**ROCKFORD BOARD OF EDUCATION
INVITATION FOR BID ON SUPPLIES, MATERIALS, EQUIPMENT OR SERVICES
FOR SCHOOL DISTRICT NO. 205
ROCKFORD, ILLINOIS**

IFB No. 22-23 HVAC & Roofing Projects at Lincoln, East, Washington & Flinn Schools

RE: **ADDENDUM NO. 9**

M206A

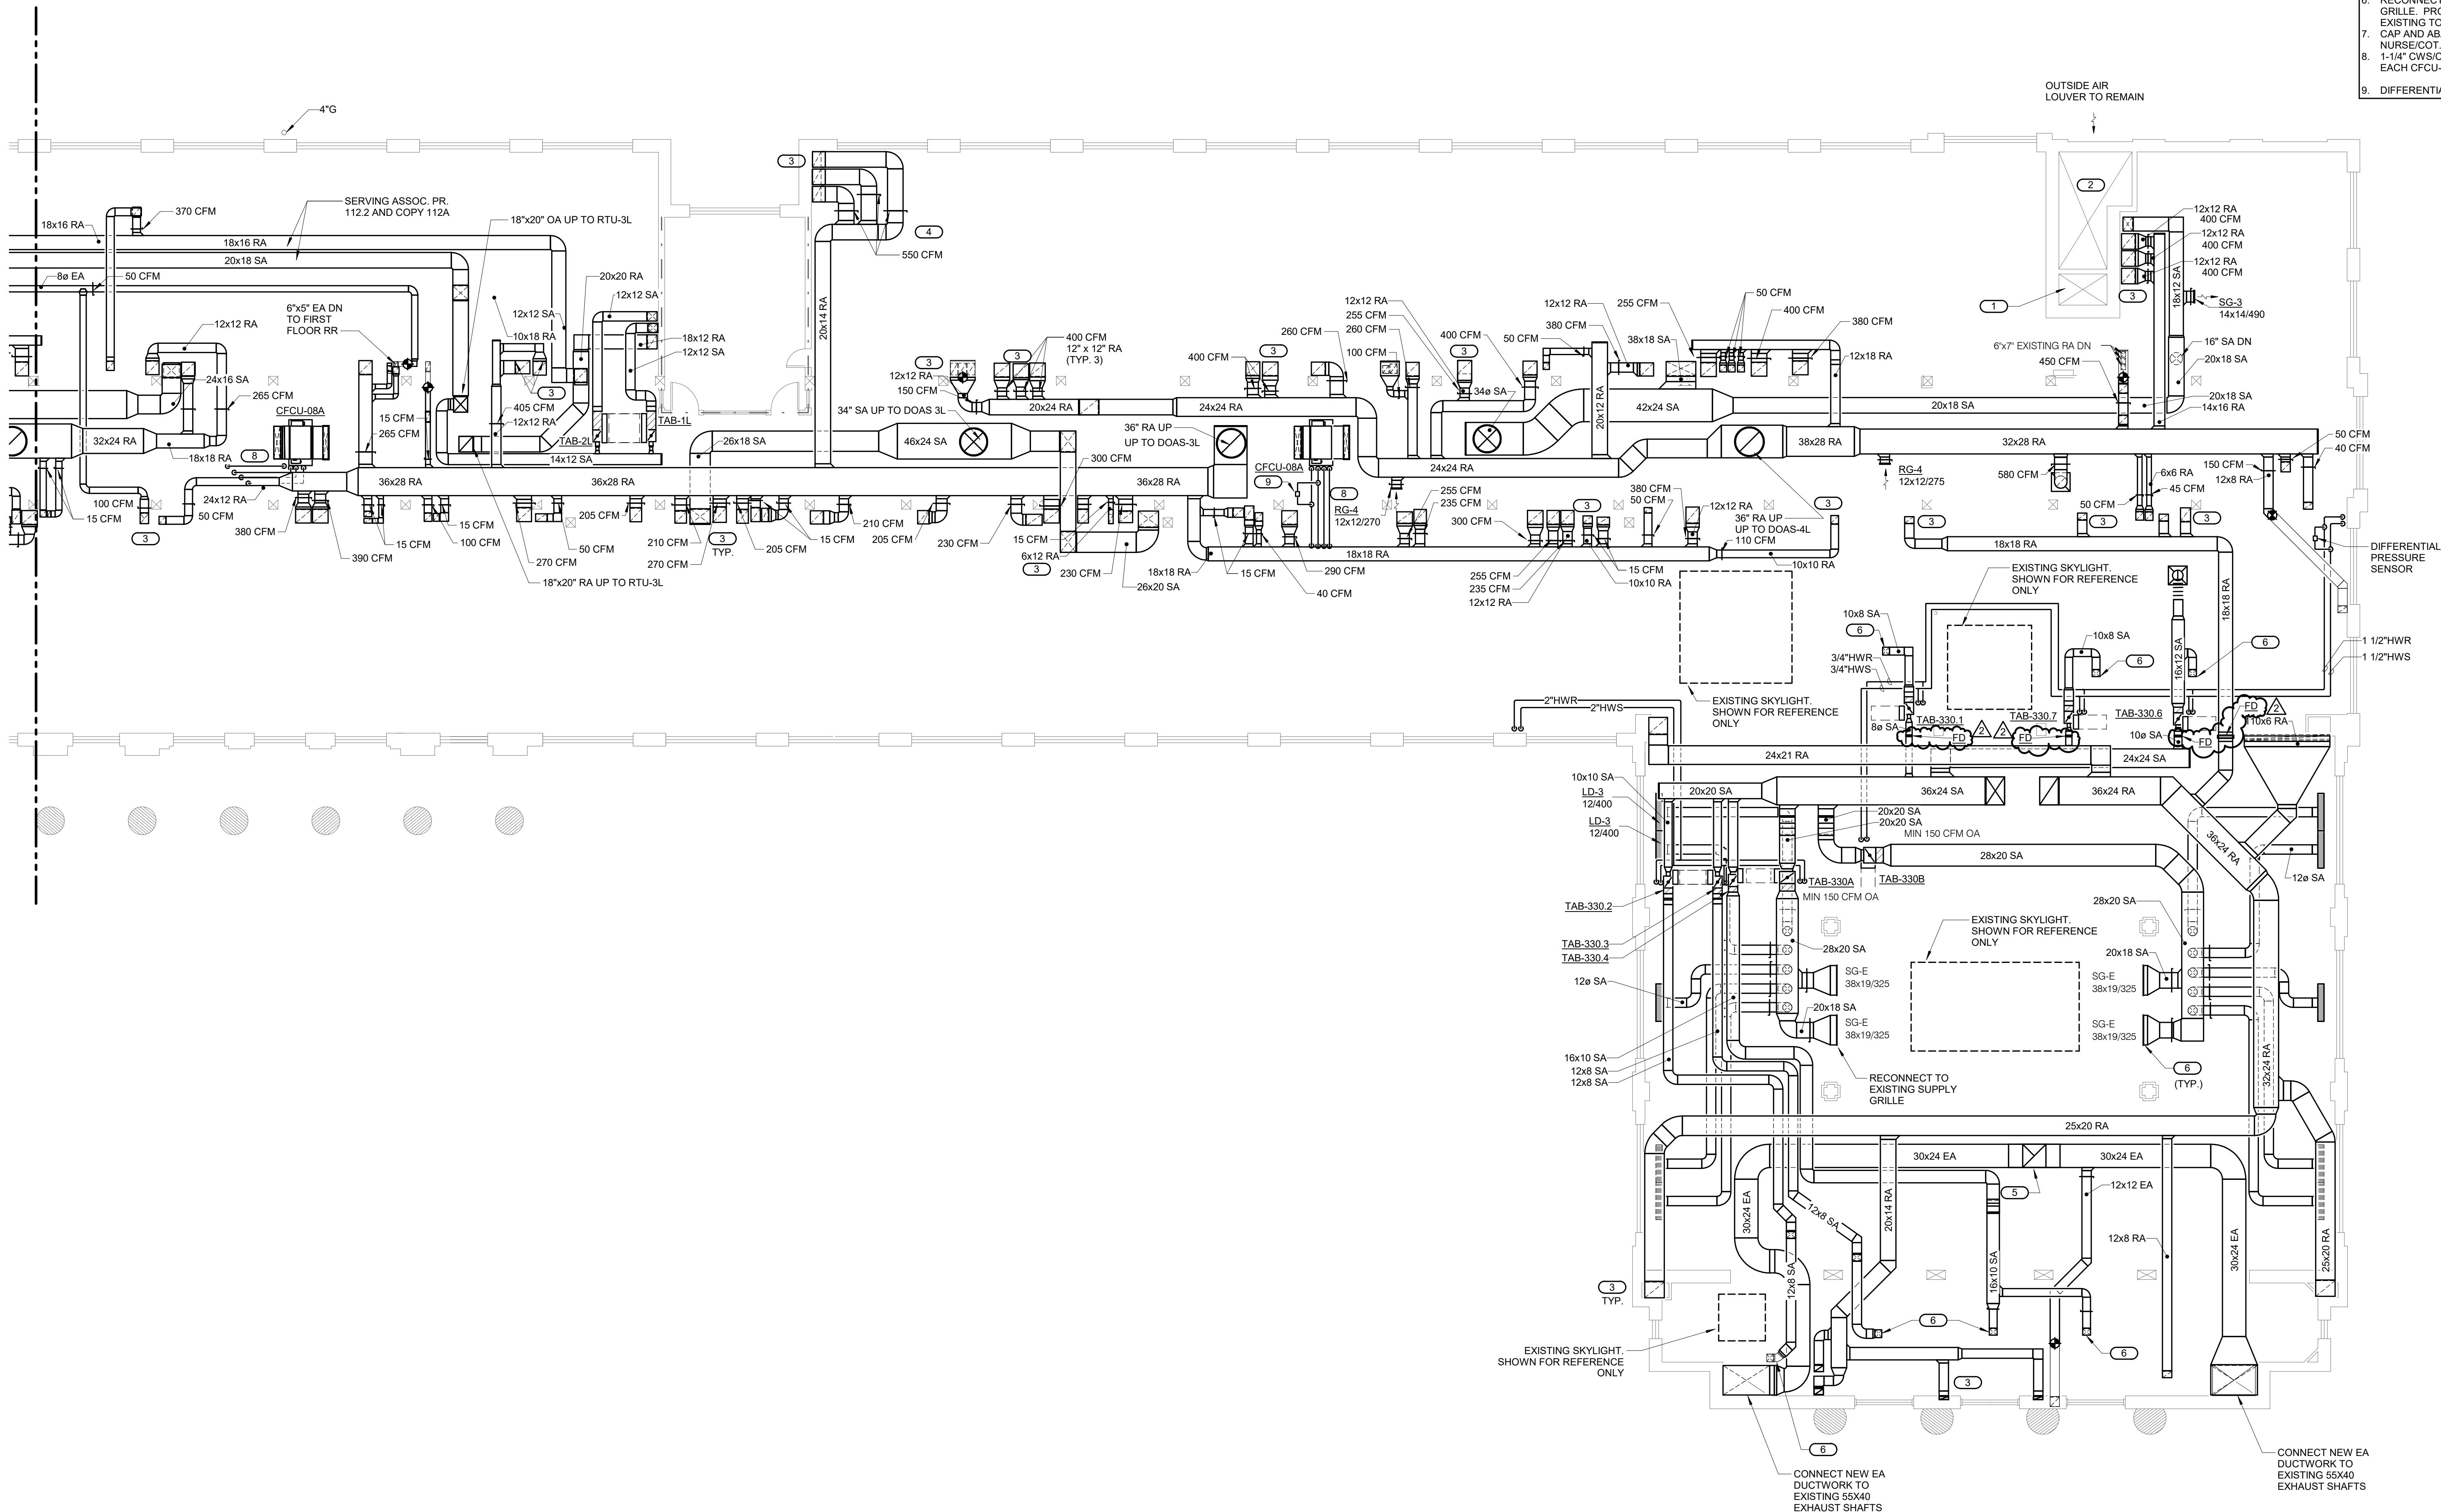
- a. **ADD** fire dampers where fire walls will be extended to roof deck, refer to architectural drawings.
 - b. Refer to attached updated drawing M206A.

M206C

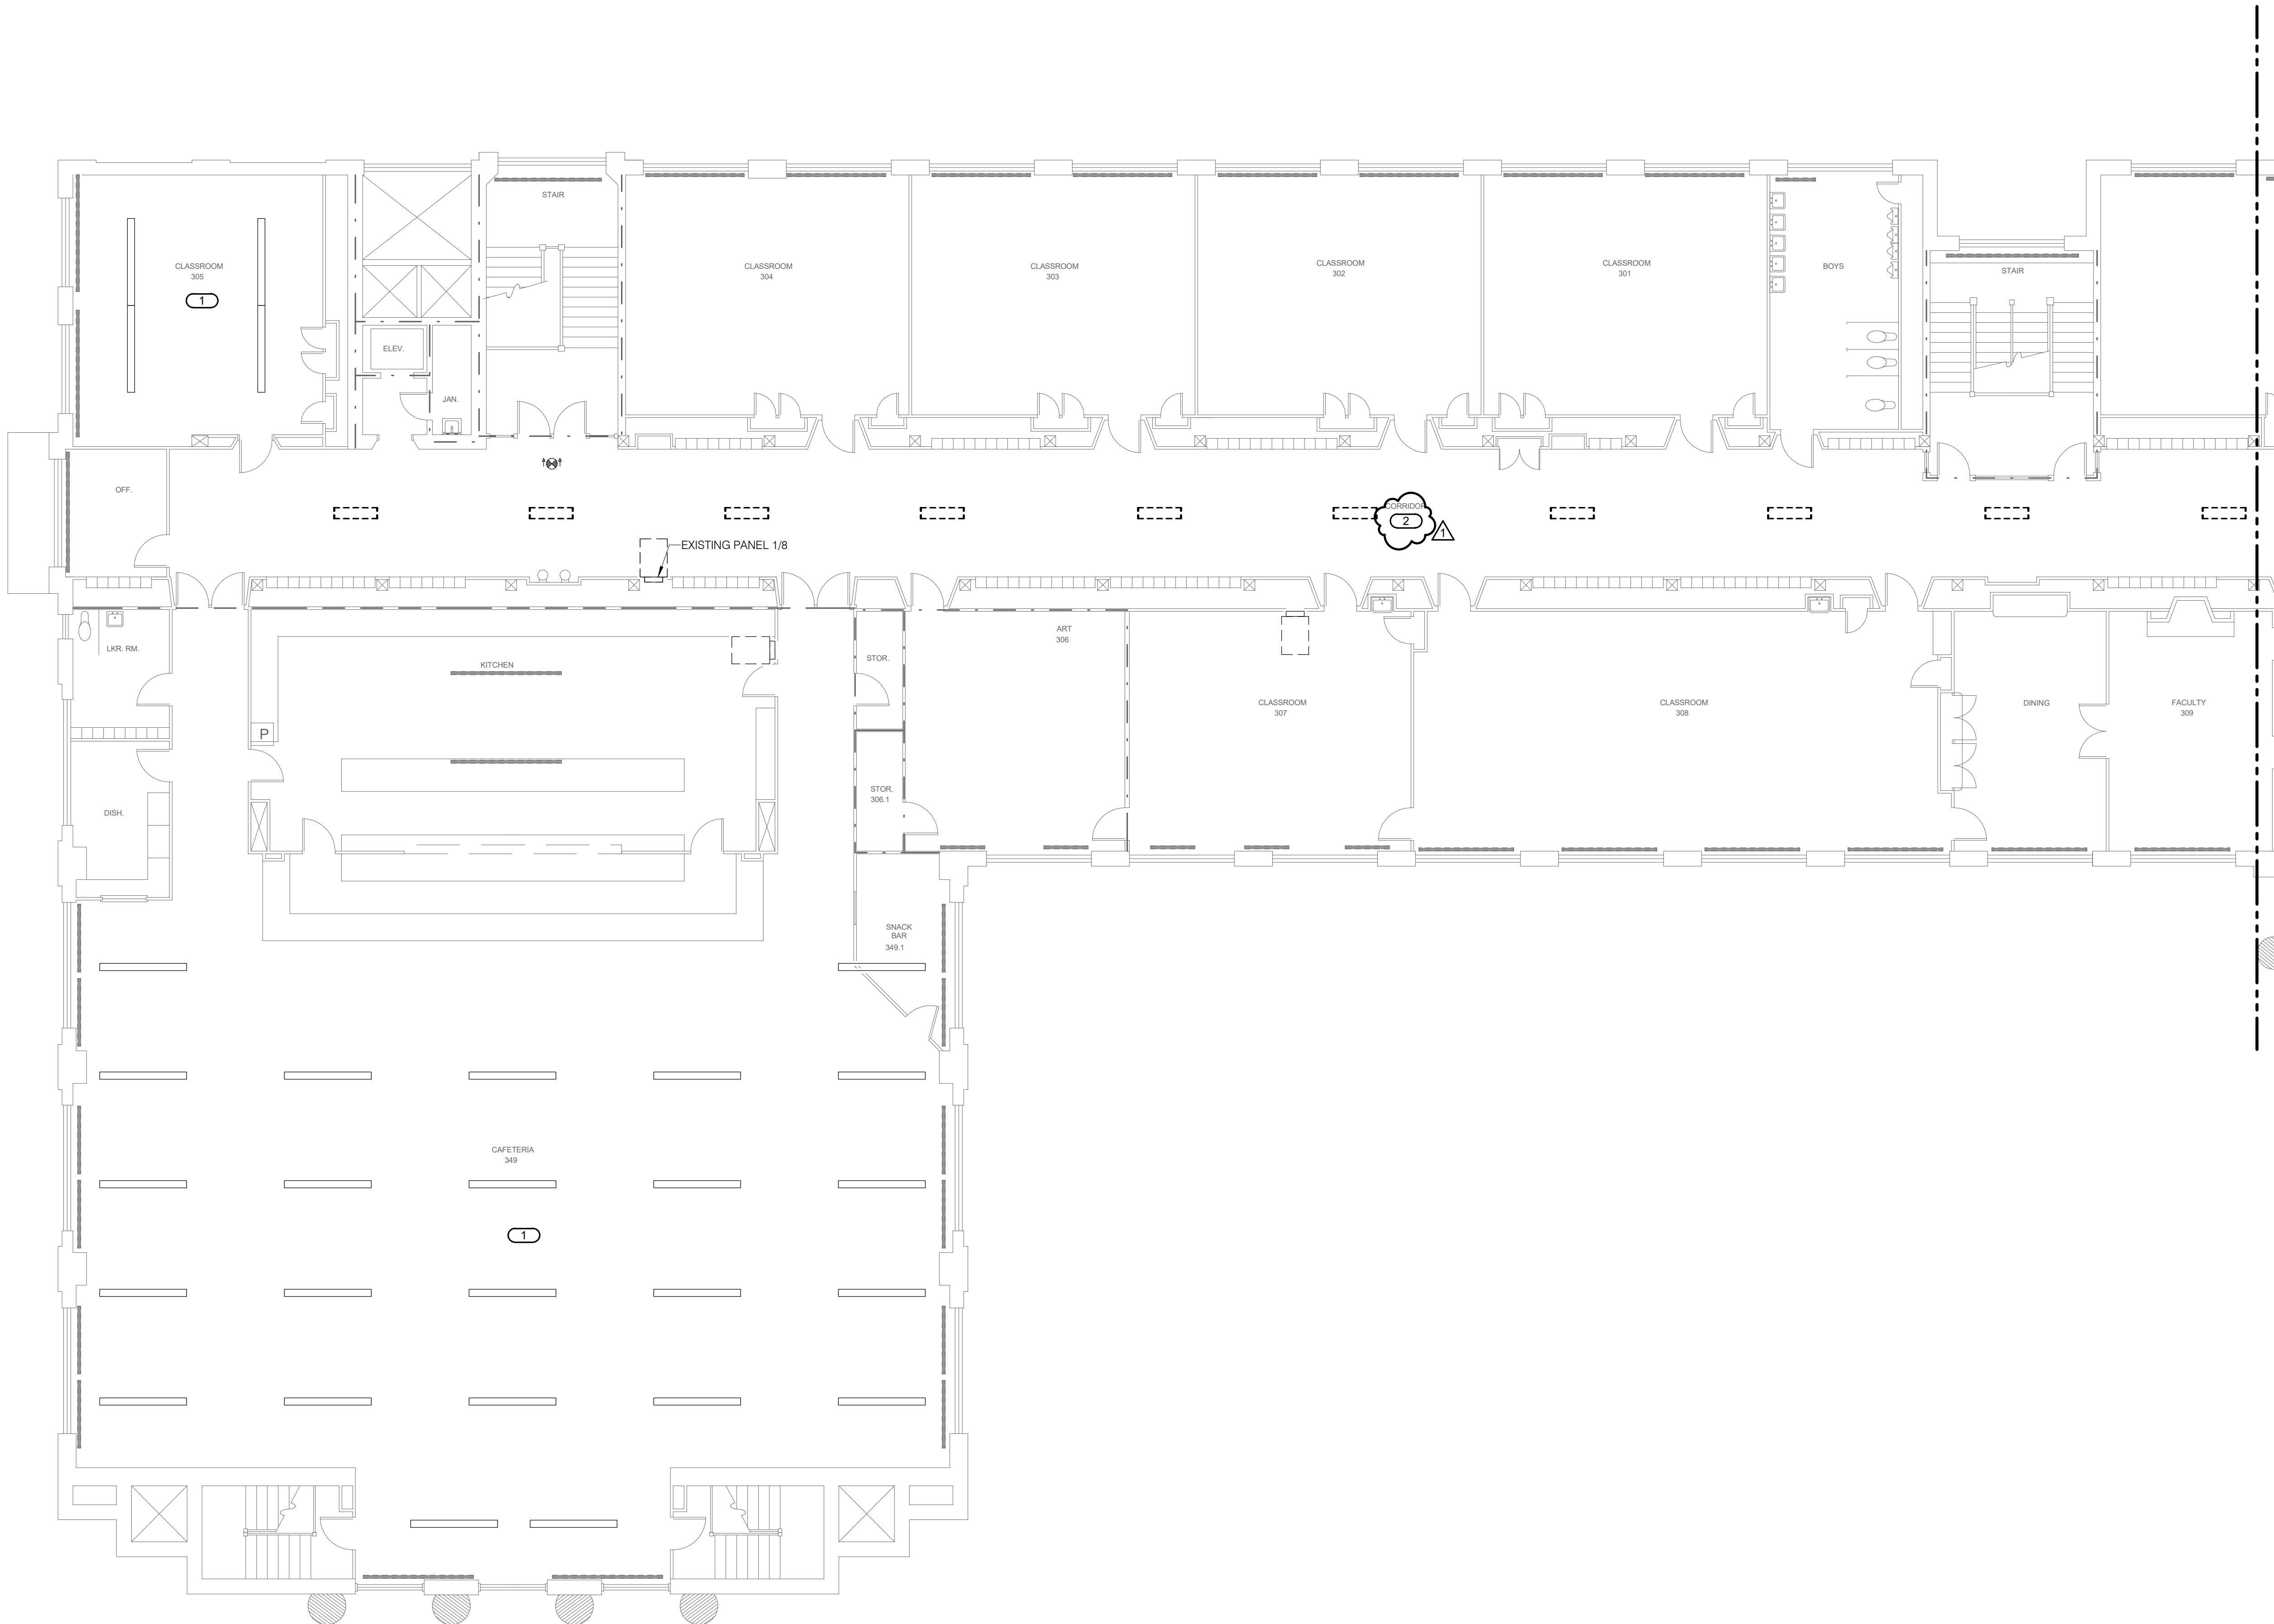
5. DRAWING M206C - MECHANICAL SCHEDULES
 - a. **ADD** fire dampers where fire walls will be extended to roof deck, refer to architectural drawings.
 - b. Refer to attached updated drawing M206C.

E105A

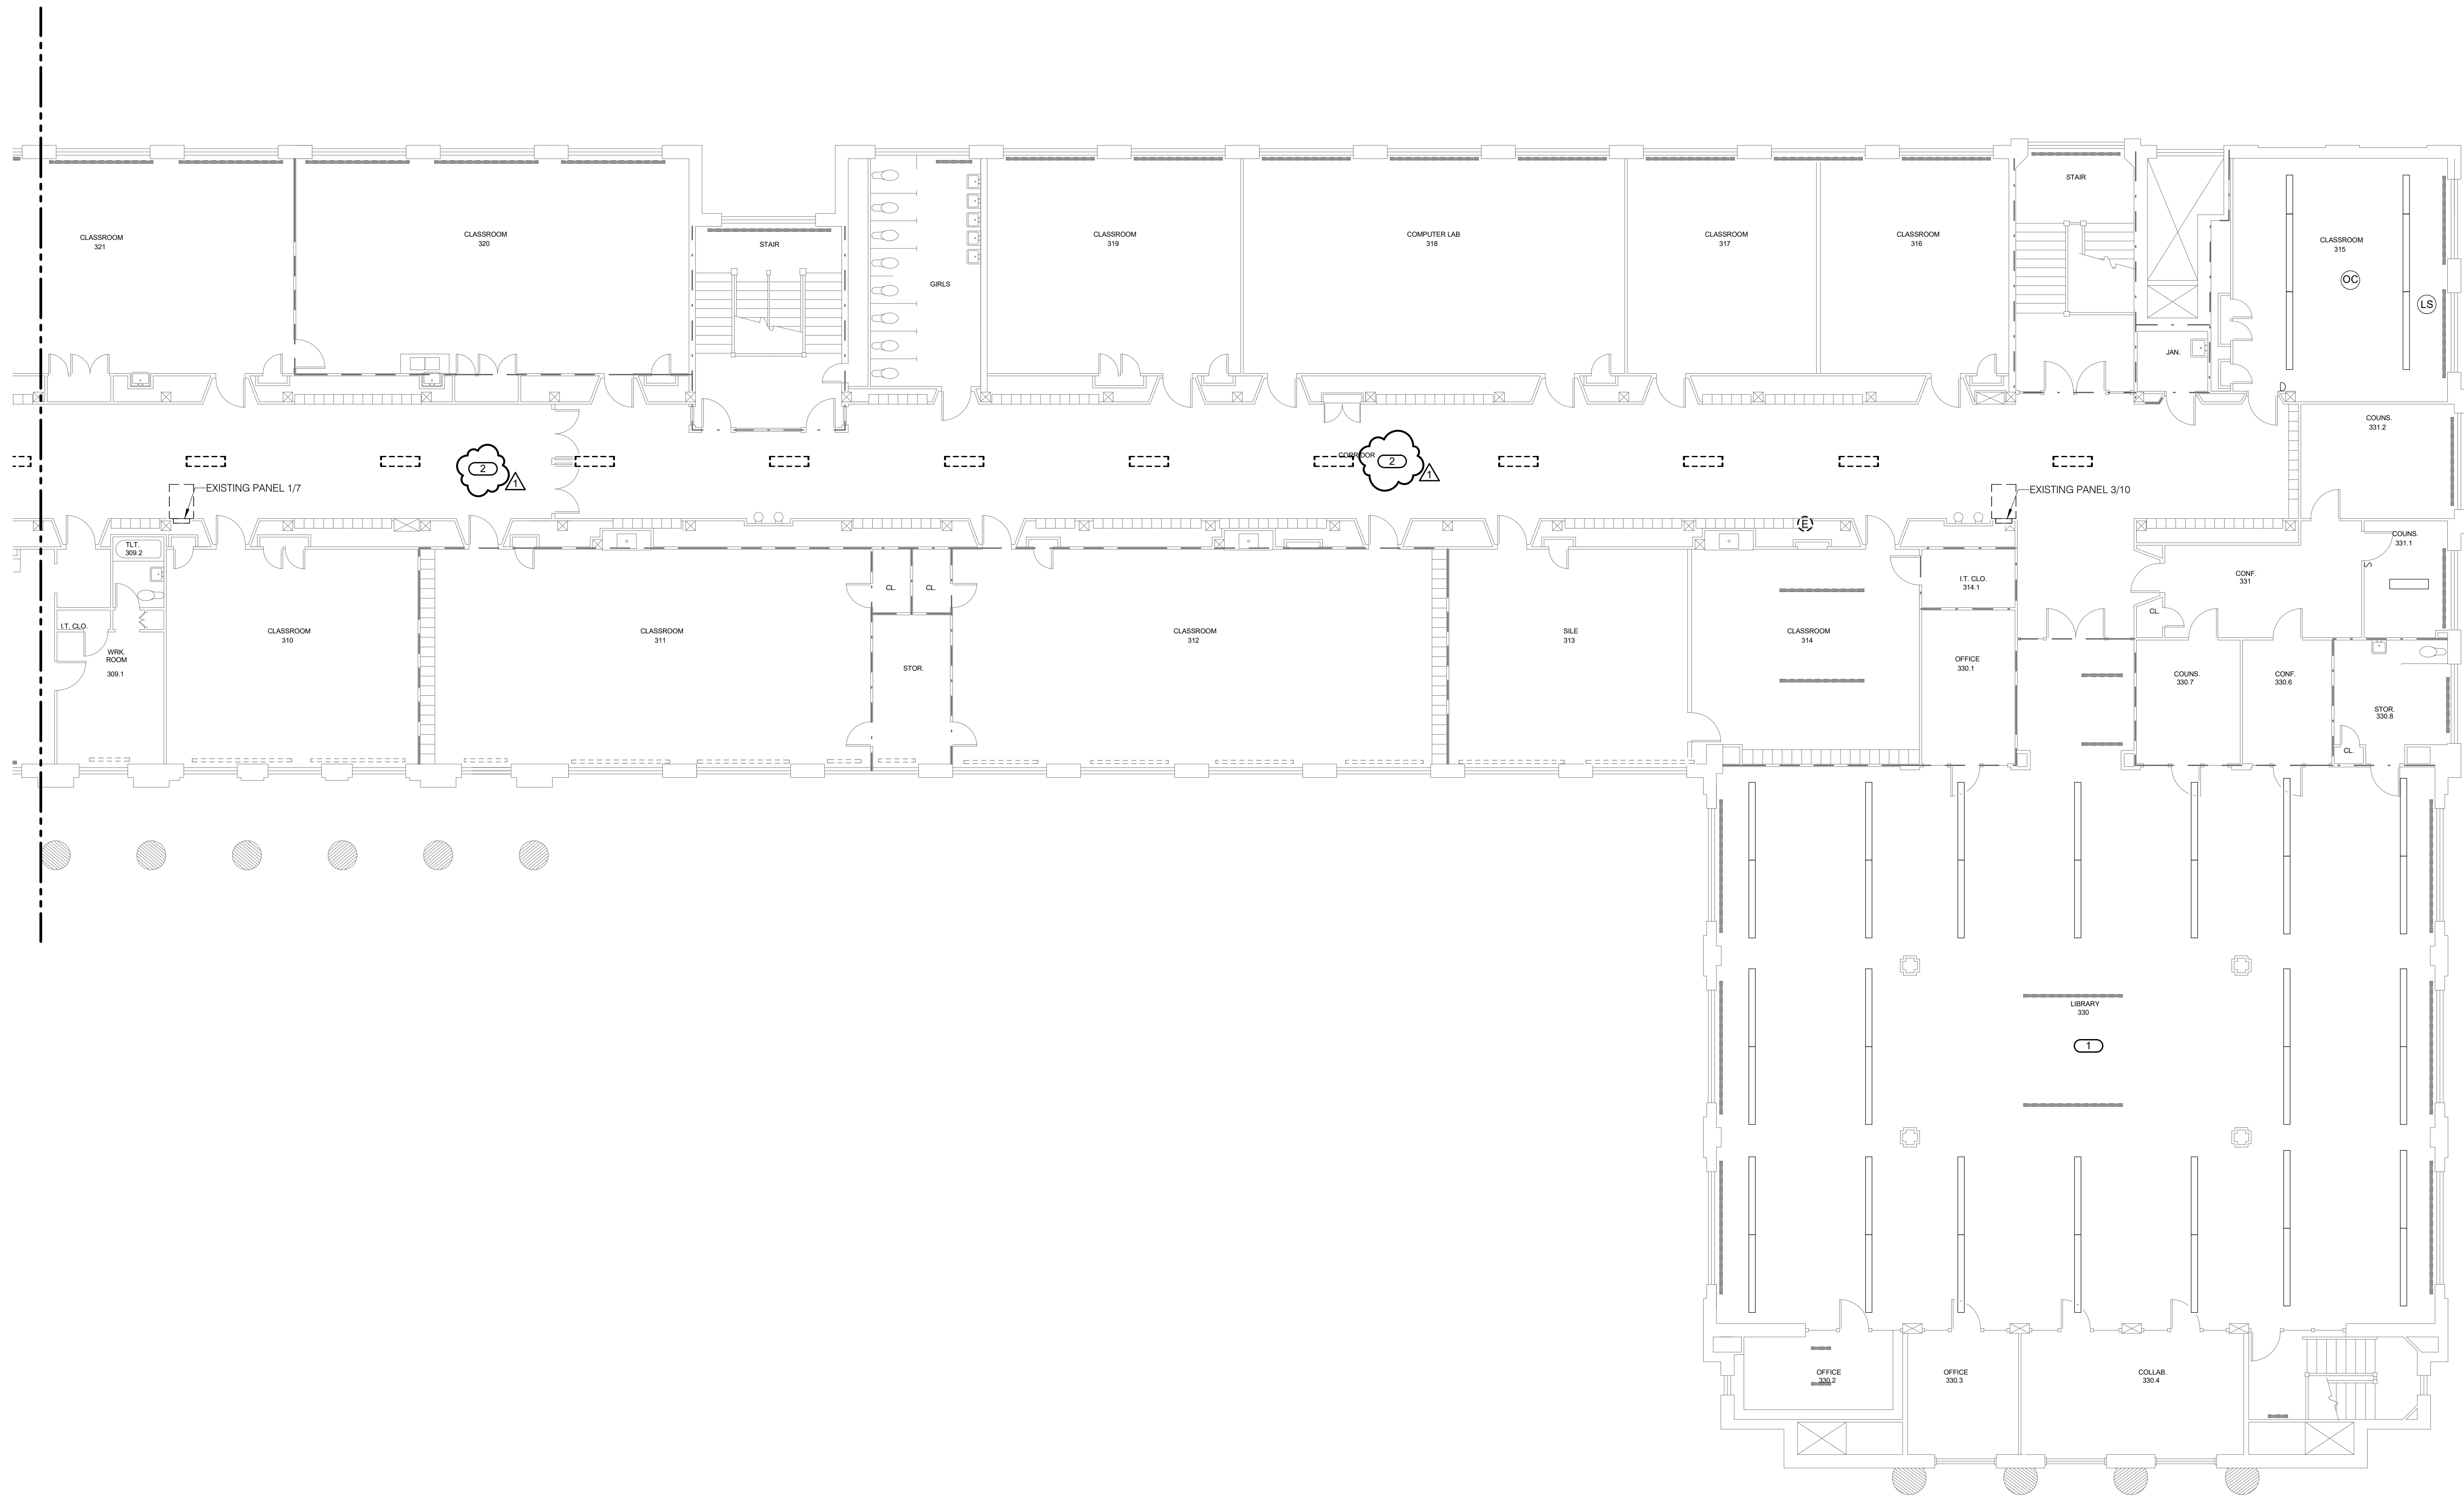
- a. **REVISE** Keynote #2 as shown on revised drawing E105A.
8. DRAWING E105C - THIRD FLOOR DEMOLITION - ELECTRICAL - AREA C
 - a. **REVISE** Keynote #2 as shown on revised drawing E105C.
